SEABROOK STATION UNIT 1

Facility Operating License NPF-86
Docket No. 50-443

License Amendment Request No. 95-05
Positive Moderator Temperature Coefficient

SEABROOK STATION CYCLE 4 MODERATOR TEMPERATURE COEFFICIENT
(ARO; Equilibrium Xenon)

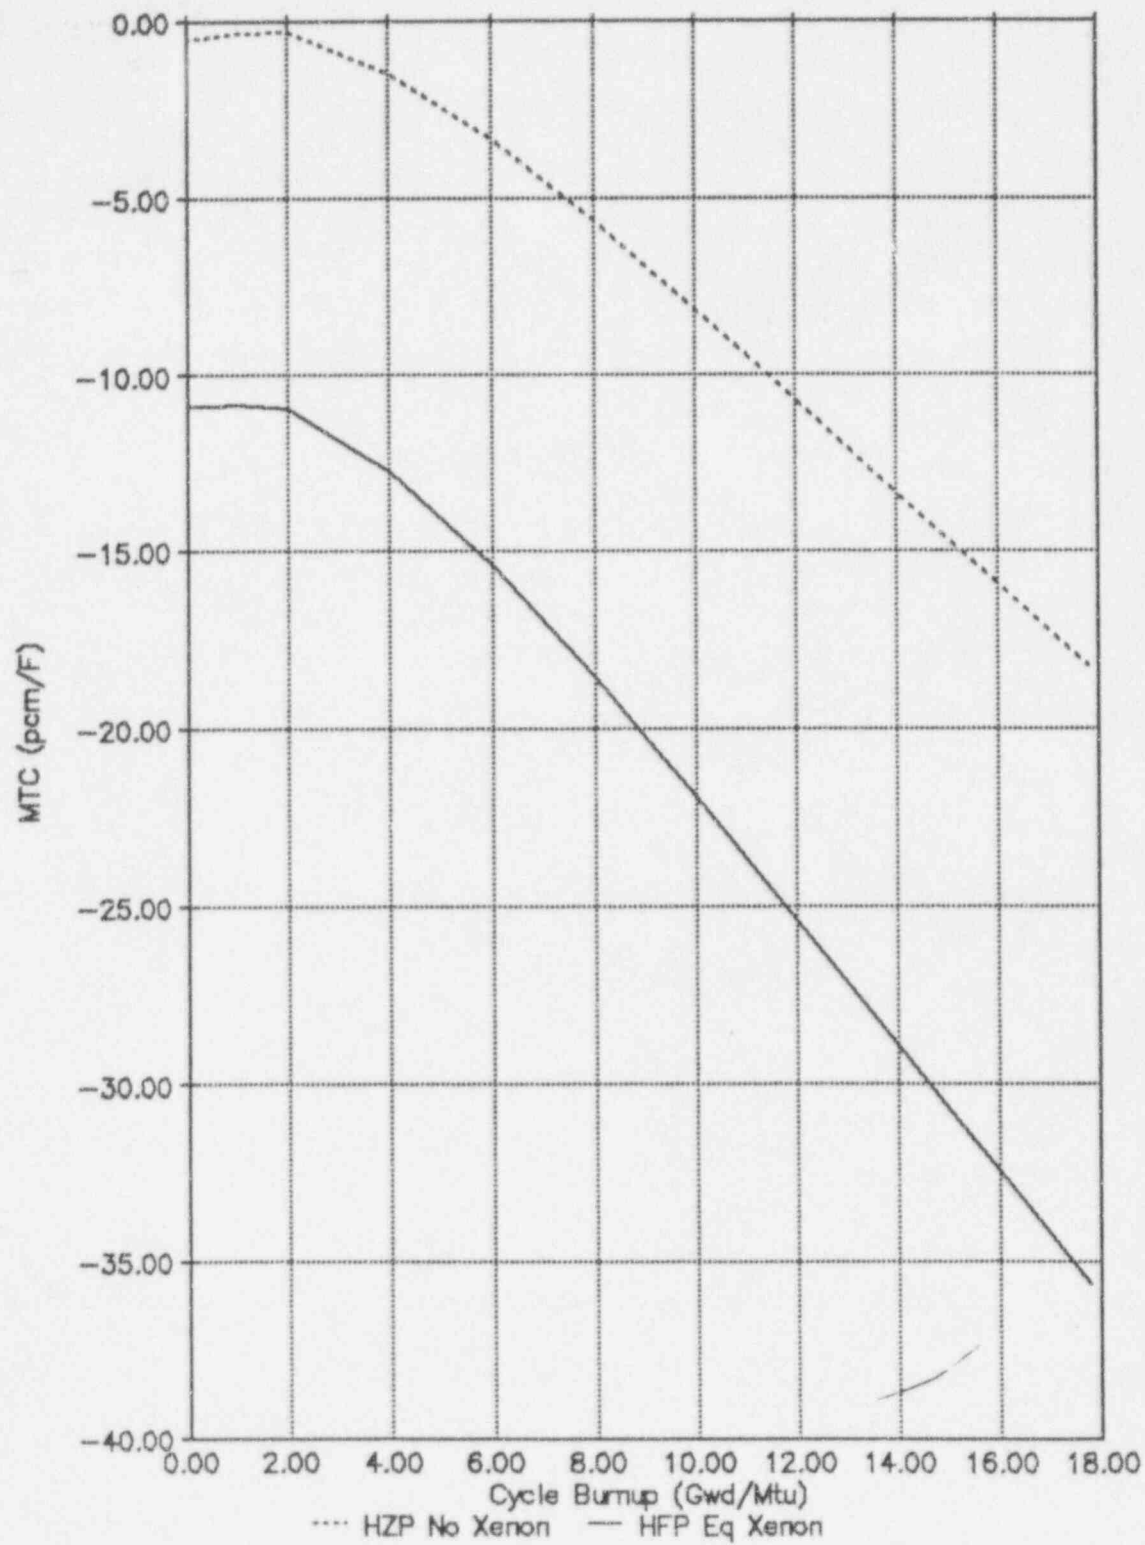
The least negative MTC values for a typical cycle occur with all control rods out (ARO) near beginning of cycle (BOC) conditions as illustrated in Figure 1. Figure 2 illustrates the least negative MTC near BOC as a function of thermal power level for a typical cycle. Figure 2 also illustrates the effect of designing a cycle with the least negative MTC limited to $-8 \text{ pcm}^\circ F$ at hot full power (HFP), ARO. This is accomplished by adjusting the amount of burnable neutron absorber and, therefore, the critical boron concentration. The behavior of MTC with cycle exposure and power level is such that for cycles designed with a limit of $-8 \text{ pcm}^\circ F$ at HFP, ARO, there will be times when the MTC is less negative. The power history of previous cycles at Seabrook Station was reviewed. The review involved determining the duration of periods when the reactor was critical but at less than full power. Assuming cycles were designed with a limit of $-8 \text{ pcm}^\circ F$ at HFP, ARO, the total fraction of time when the MTC would have been less negative was determined. The conclusion is that the MTC of previous cycles designed with a

SEABROOK STATION CYCLE 4 MODERATOR TEMPERATURE COEFFICIENT
(BOC; ARO; Equilibrium Xenon)

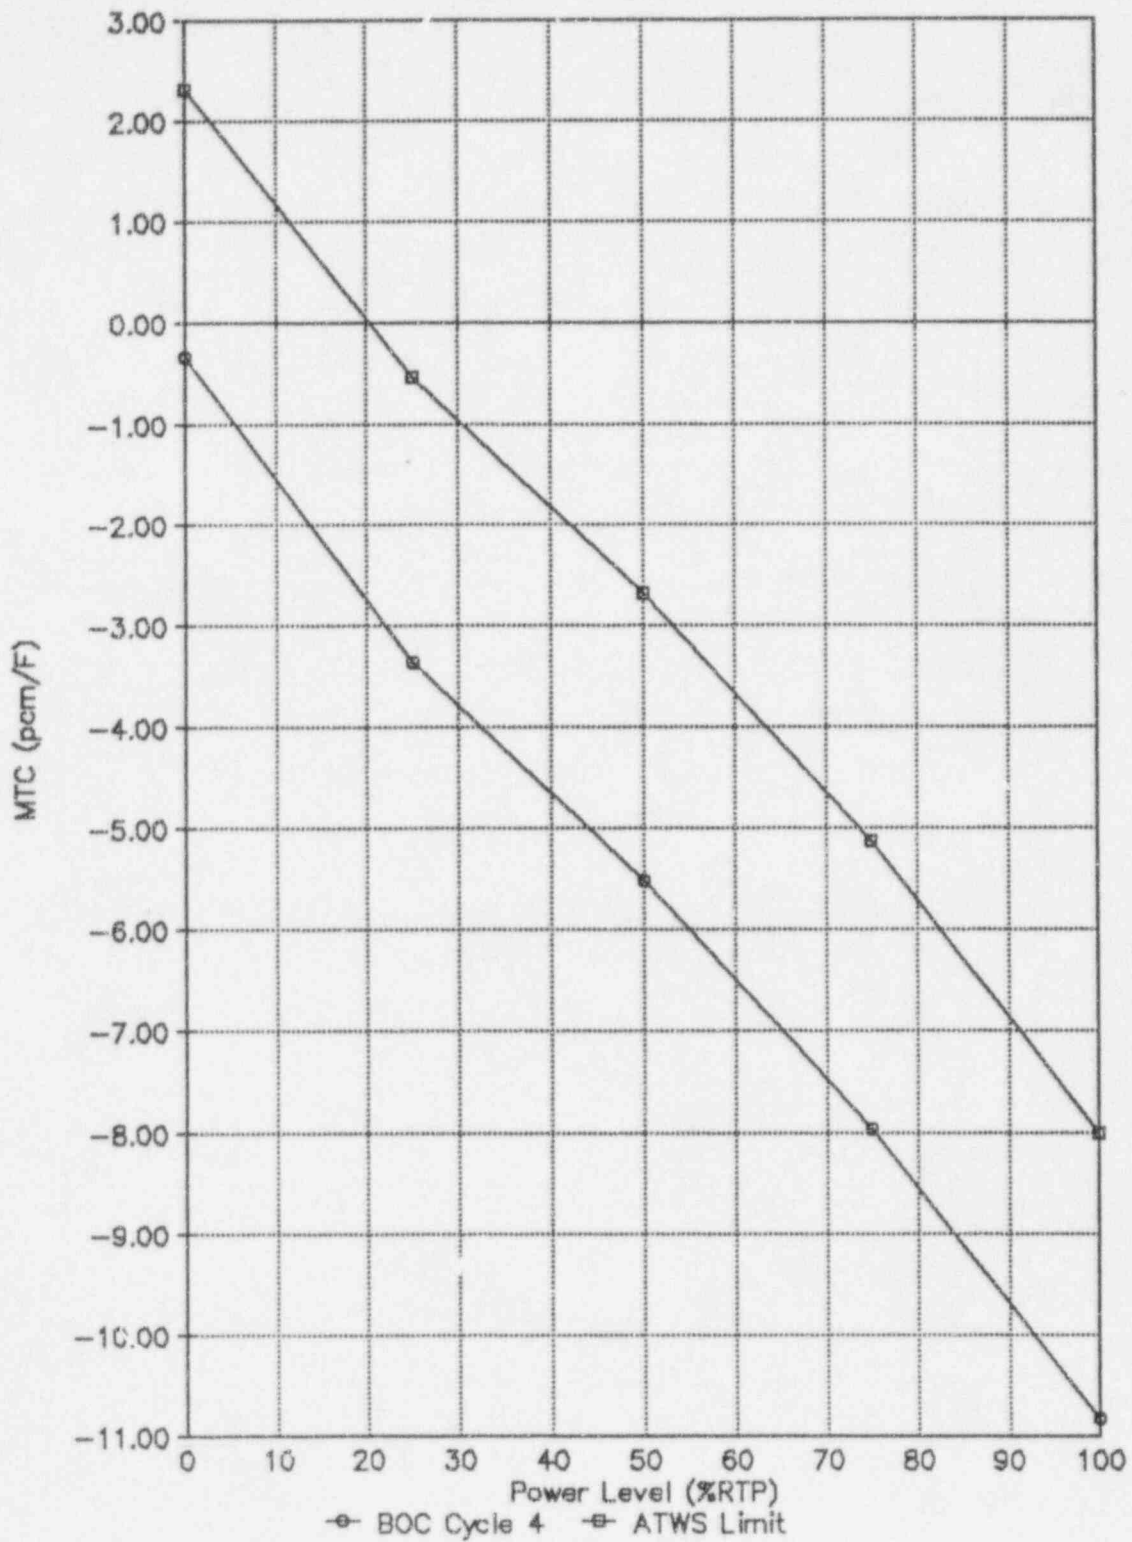
Upon approval of this LAR, the cycle specific upper MTC limit will be changed to the value determined using the analytical method described herein. Typical MTC values with ARO, BOC are shown in Figure 1. Using the example of the typical core illustrated in Figure 2, the above COLR limit would be changed to:

Technical Specification Surveillance Requirement 4.1.1.3.a states that the MTC shall be measured and compared to the BOC limit specified in the COLR, prior to initial operation above 5% of rated thermal power, after each fuel loading. Figure 2 illustrates the hot zero power (HZP), ARO, MTC limit which should be placed in the COLR for a typical cycle to assure that the limiting HFP, ARO MTC is not less negative than $3 \text{ pcm}/^{\circ}\text{F}$. From Figure 2, the upper MTC limit for a typical cycle would be $2.3 \text{ pcm}/^{\circ}\text{F}$.

The Moderator Temperature Coefficient (MTC) shall be less positive than $+0.23 \times 10^{-4} \Delta k/k^\circ F$ for Beginning of Cycle Life (BOL), All Rods Out (ARO), Hot Zero Thermal Power Conditions.
